Subject: **WATER AND WASTEWATER CAPACITY AVAILABILITY LETTER**
LA Lee YMCA Mizell Community Center – DRC Case No. R19004
1409 NW 6th Street, Fort Lauderdale, Florida 33311

City of Fort Lauderdale
Public Works Department
Water and Wastewater Capacity Analysis

LA Lee YMCA Mizell Community Center – DRC Case No. R19004
1409 NW 6th Street, Fort Lauderdale, Florida 33311

Figure 1 – City Water Atlas

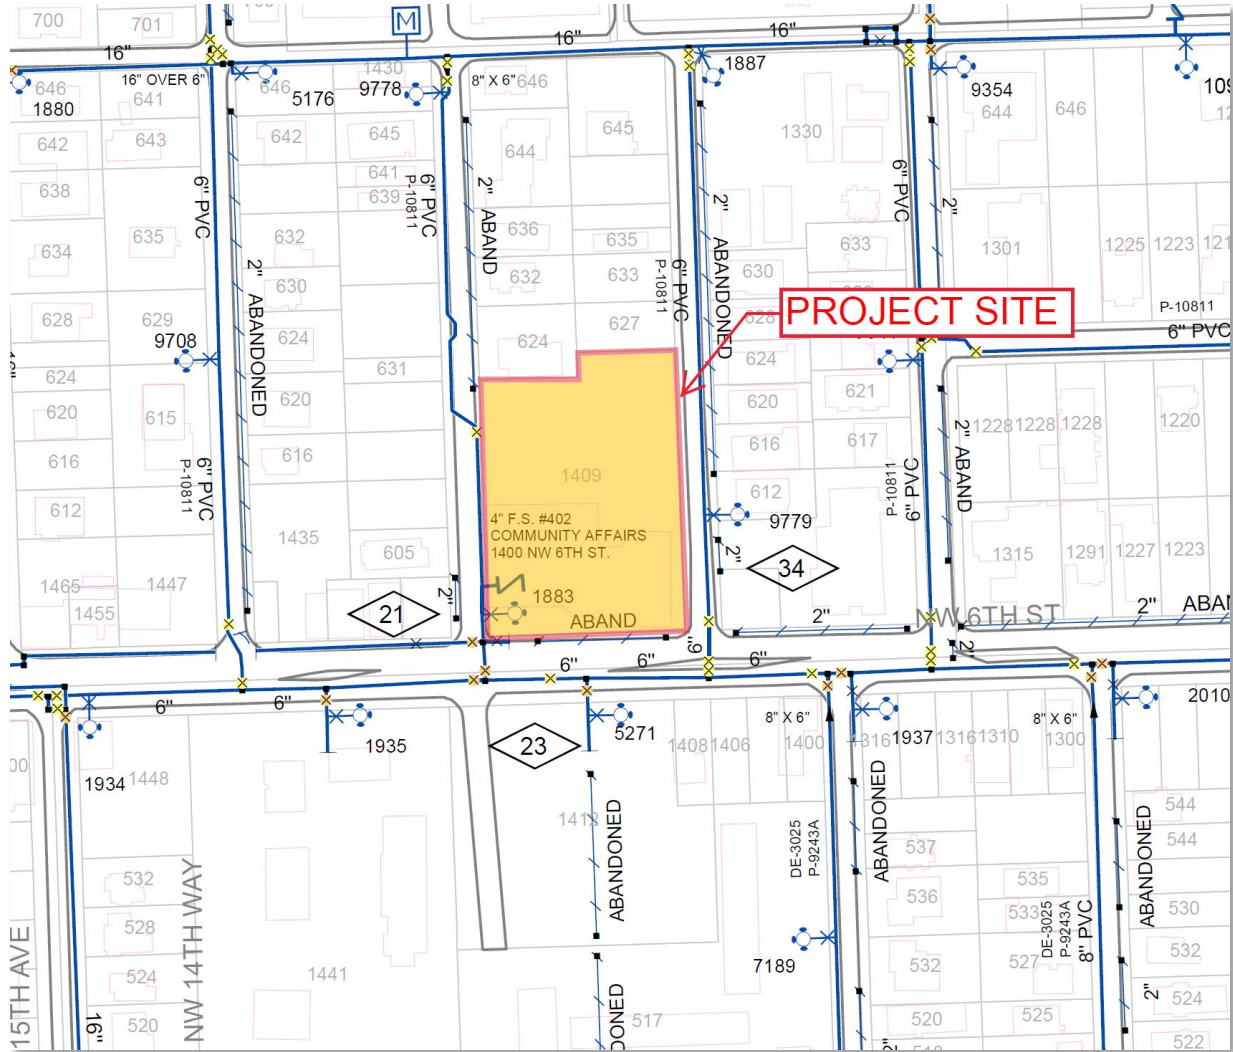
Water: The site is currently served by a 6-inch water main to the west of the property along NW 14th Terrace. See Figure 1.

Evaluation of impact on existing distribution pipe (flow & capacity): According to the site plan the applicant is proposing to utilize the 6-inch water main along NW 14th Terrace to the west of the property. The InfoWater hydraulic model was analyzed to determine the impact of this project on the existing 6-inch water main and it was determined that the existing main can sufficiently serve the project.

Recommended Water Infrastructure Improvements: No improvements required.

Figure 2 – City Sewer Atlas

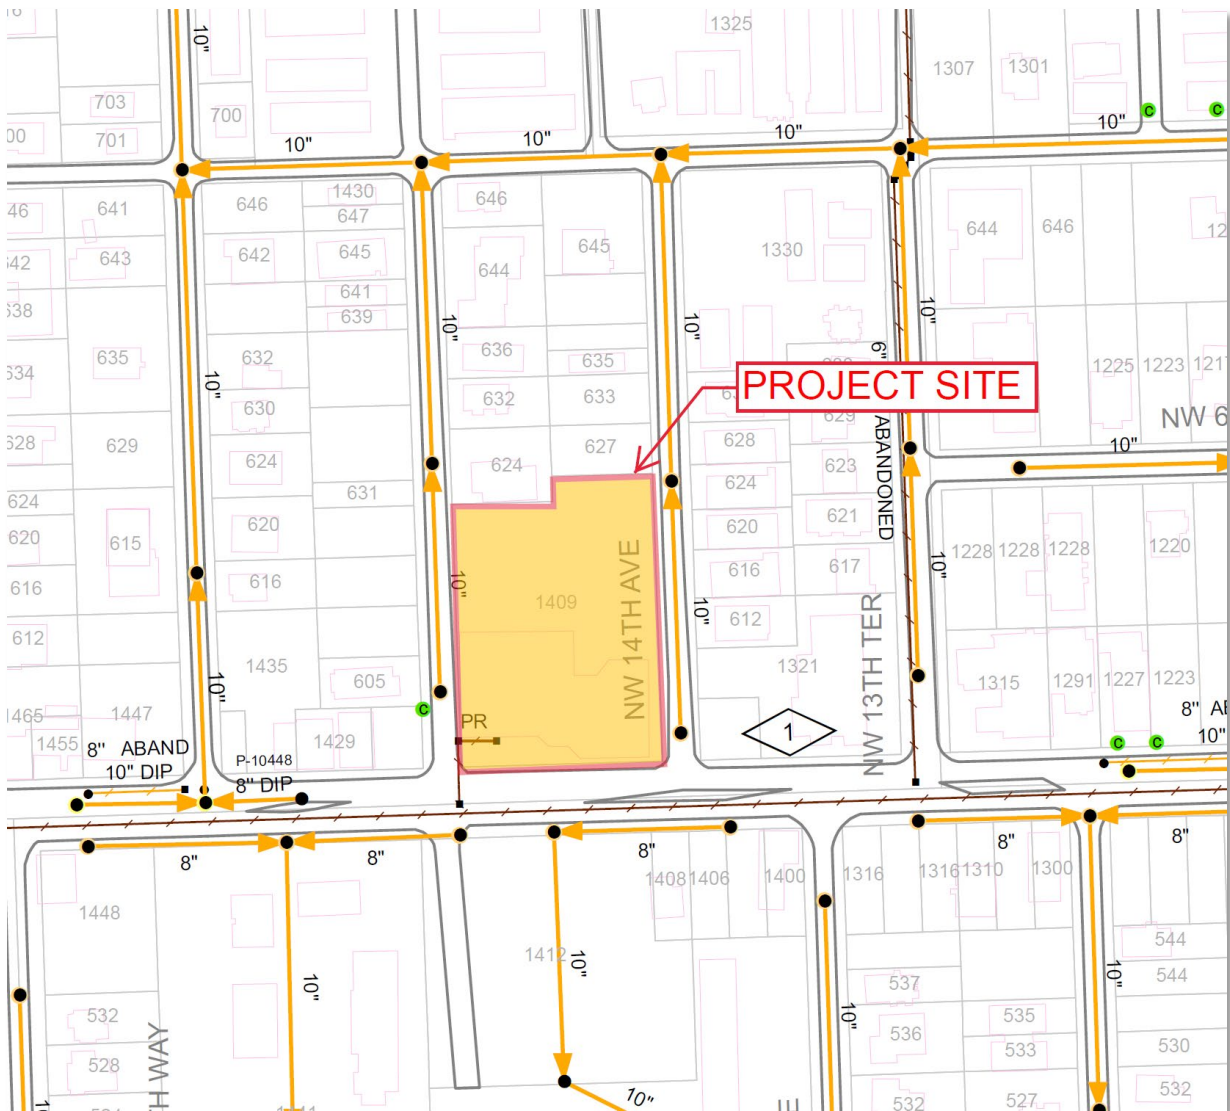
Wastewater: The site is currently served by a 10-inch gravity sewer main to the east of the property along NW 14th Avenue. See Figure 2.

Evaluation of impact on existing collection pipe (gravity system capacity): The existing site and adjacent buildings are served by an 10-inch gravity sewer main along NW 14th Avenue to the east of the property.

Manual of Practice (MOP) 60, published by American Society of Civil Engineers (ASCE) for the gravity sewer design and used by the City staff, recommends that pipe diameters 15-inch or less be designed to flow half full during peak flows. The City uses a peak hourly flow factor of 3.0. Accounting for existing flows and based on the tools and information available to the City staff, it has been calculated that the 10-inch diameter pipe will flow approximately 24% full during peak conditions, which is less than the ASCE-recommended 50%. Therefore, the 10-inch pipe is adequate to serve the project.

Recommended Wastewater Infrastructure Improvements: No improvements required.

Figure 3

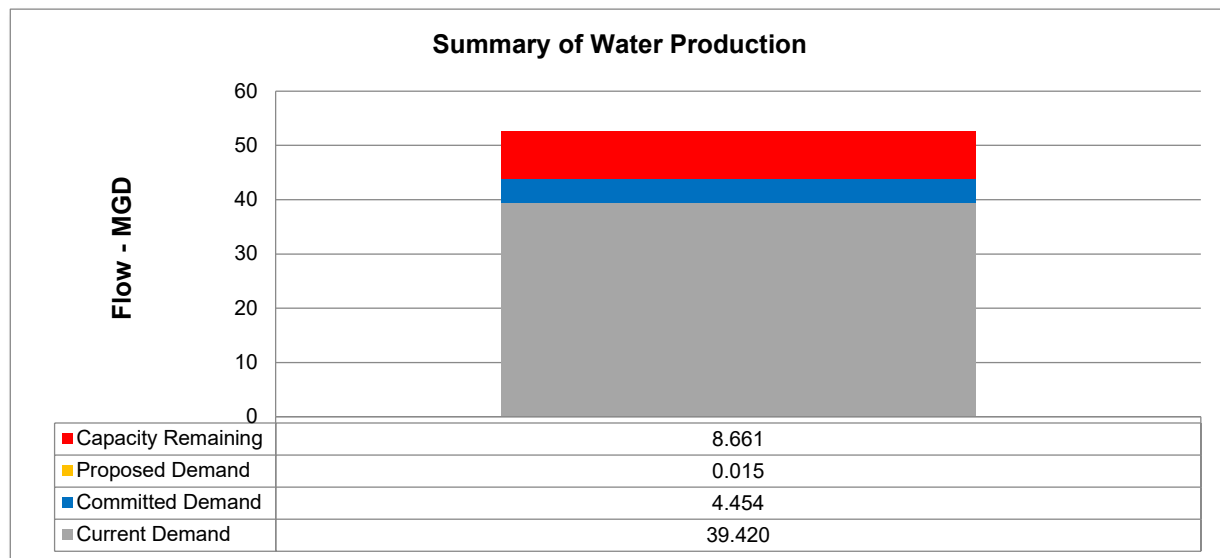
Evaluation of impact of Permitted Water Plant Capacity: The Fiveash and the Peele Dixie Water Treatment Plants are designed to treat 70 MGD and 12 MGD of raw water respectively (82 MGD total). The total permitted Biscayne aquifer water withdrawals for these plants is limited to 52.55 MGD per the South Florida Water Management District (SFWMD) permit number 06-00123-W.

The current twelve-month rolling average production at the two plants is 39.42 MGD. The previously committed demand from the development projects in the permitting or the construction stage is 4.454 MGD. Combining these figures with the demand from the proposed project of 0.015 MGD, the required production would be 43.89 MGD. This is less than the allowable withdrawal limit of 52.55 MGD. Therefore, the water plants have sufficient capacity to serve this project. See Figure 3 below.

Figure 4

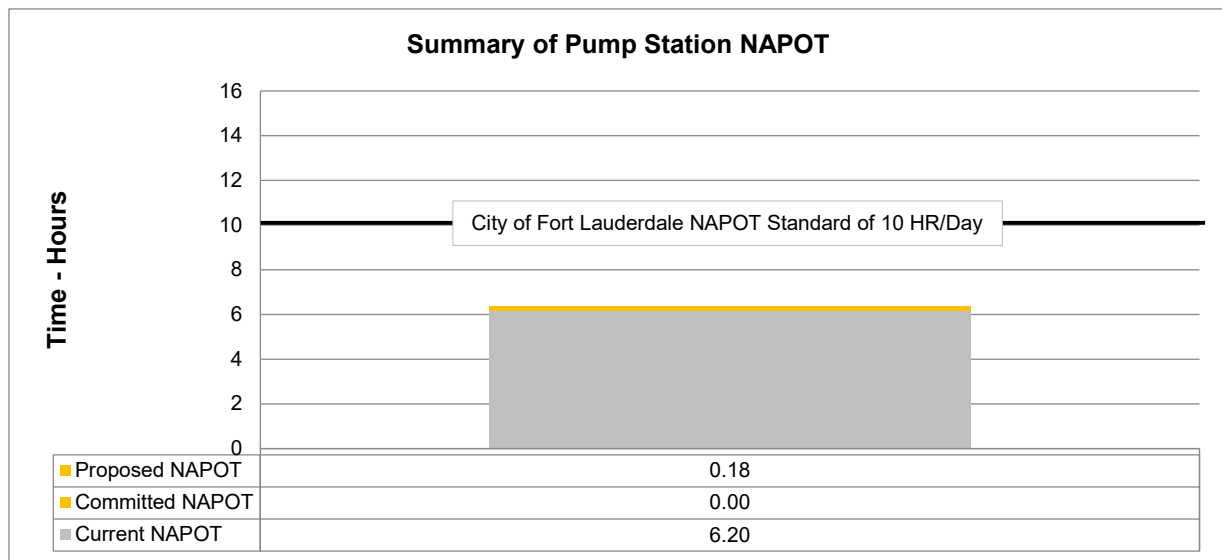
Evaluation of impact on pumping station: PS A-23 has a capacity of 1400 gallons per minute (GPM) and currently has a Nominal Average Pumping Operating Time (NAPOT) of approximately 6.2 hours per day. Based on projected sewage flows, the pumping run times would increase approximately 11 minutes per day. The total NAPOT of PS A-23 will have a NAPOT of approximately 6.4 hours once the proposed developments are complete, less than the recommended average of 10 hours per day (see Figure 4).

Figure 5

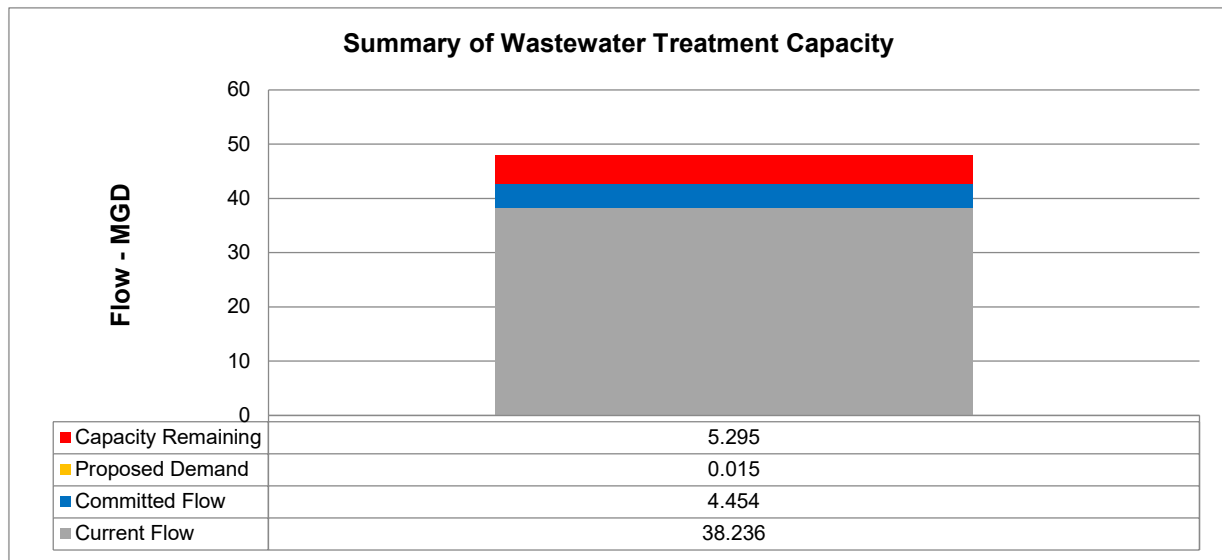
Evaluation of impact of Permitted Wastewater Plant Capacity: The City of Fort Lauderdale owns and operates the George T. Lohmeyer Regional Wastewater Treatment Plant (GTL), which provides wastewater treatment for the City of Fort Lauderdale. The Broward County's Environmental Protection and Growth Management Department's (EPGMD) Environmental Licensing & Building Permitting Division's licensed capacity for GTL is 48 MGD Annual Average Daily Flow (AADF). The current AADF to the plant is 38.236 MGD. Combining the committed flows for previously approved projects of 4.454 MGD plus the 0.015 MGD net contribution from the project results in a total projected flow of 42.71 MGD. This is less than the permitted treatment plant capacity of 48 MGD. Therefore, the treatment plant has sufficient capacity to serve this project. See Figure 5 below.
